RECALL ACTION

Recall Action Number:
BD148v3

Subject Reinforce ABS Modulator Pressure Reduction Valve Reaction Plates	Publication No.	BD148v3
	Model	Discovery Series II (LT) and Defender (LD) - Fitted with ABS
	Model Year	1999 to 2004
	VIN Range	<u>Discovery Series II</u> XA 900000 to XA 907213 VA 200000 to 4A 846247 XJ 920000 to 3J 920651 (CKD) <u>Defender</u> XA 159810 to YA 199999 YA 600000 to 4A 671407 2V 848879 to 2V 849999 (CKD) 2V 050000 to 3V 052562 (CKD)
	Date of Issue:	23/06/04

RE: Reinforce ABS Modulator Pressure Reduction Valve Reaction Plates

Fig. 1

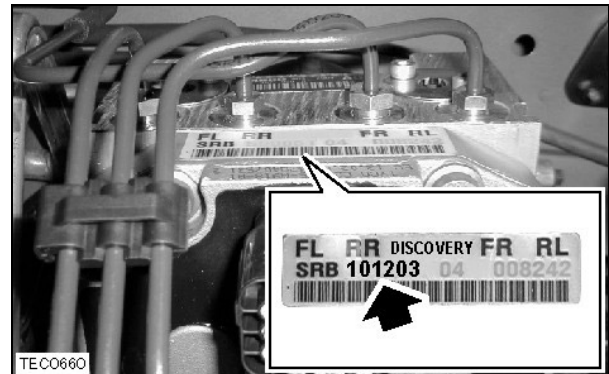
To identify a new specification modulator, note the service part number on top of the modulator (see Fig. 1 and 2). If the following service part numbers have been noted, no further action is required:

- SRB101203 - (Discovery Series II)
- SRB101552 - (Defender)

Also, if the following production part numbers are noted, no further action is required:

- SRB500051 - (Discovery Series II)
- SRB500041 - (Defender)

Fig. 4

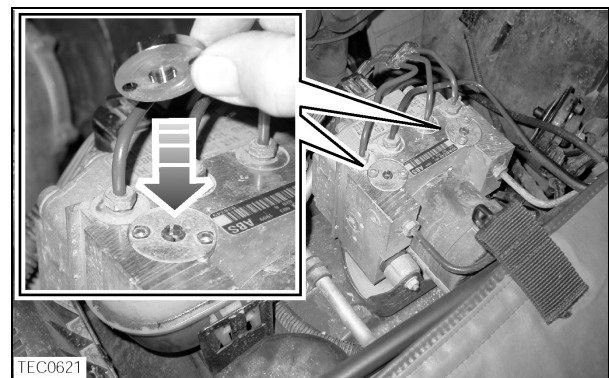
4. Install the additional reinforcing covers on the top of the existing reduction valve reaction plates (recess facing downwards), making sure the recess in the cap clears the plastic clip (see Fig. 4).

CAUTION: DO NOT INSTALL THE NEW REINFORCING COVERS FROM THE KIT IF THERE IS A HOLE RATHER THAN A RECESS IN THE CENTRE OF THE COVER.

Fig. 5

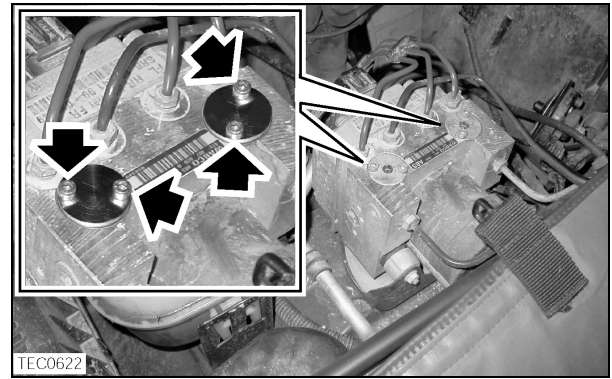
5. Install new Allen screws (arrowed in Fig. 5) and tighten to 6 Nm (4 lb.ft).
